Docket Item # 4  
BAR CASE #2006-0108

BAR Meeting  
February 21, 2007

**ISSUE:** New single family dwelling

**LOCATION:** 508 North Quaker Lane

Figure 1 - Site Plan

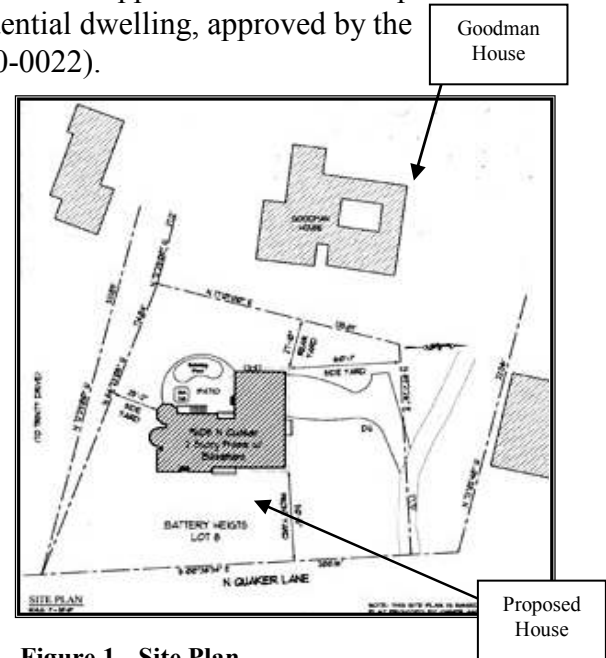
The proposed two-story frame with full basement, single-family house has a total square footage of 8,123. It will be situated more or less in the center of the 23,452 square foot lot and will face North Quaker Lane. The house will be located approximately 50'5" from the North Quaker Lane (the DSUP requires a minimum of 40' front yard setback adjacent to Quaker Lane.) There will be a 25'2" sideyard setback on the south side of the lot and a 60'1" setback on the north side of the lot. Approximately 60' separates the proposed house from the Goodman House. The height of the house will be 34'6" to the ridgeline, and 27'4" to the midpoint of the gable roof. The primary façade is 69'4" in width and the side elevations are approximately 55' wide. The first floor will have a 10' floor height exterior expression, while the second floor will have 9' height exterior floor expression. The footprint of the house is somewhat L-shaped.

Figure 3 - North Elevation

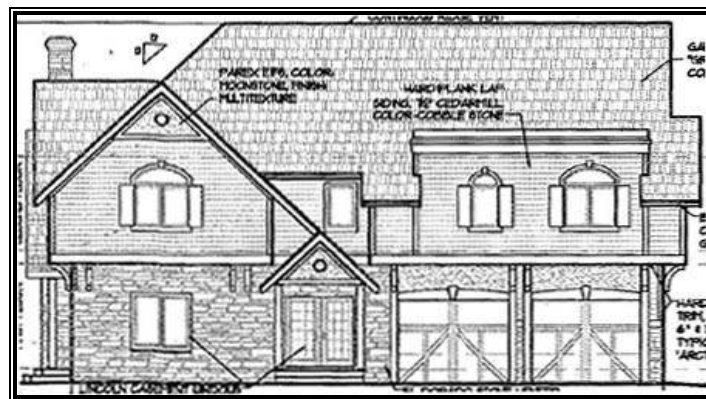
The North elevation contains the double garage. The asymmetrical character of the front façade is echoed on the north elevation, with a combination of gable elements and a flat roofed corniced section over the garage entrances. A portico side entrance with paired French-style doors provides access for this elevation. The South elevation, creates the ell and continues the asymmetrical design expression, while incorporating two rounded, “tower” elements, both two stories in height, with conical roof shapes. One “tower” elements has three narrow casement windows at the ground level. The second “tower” element is open on the second level, creating a covered porch area.
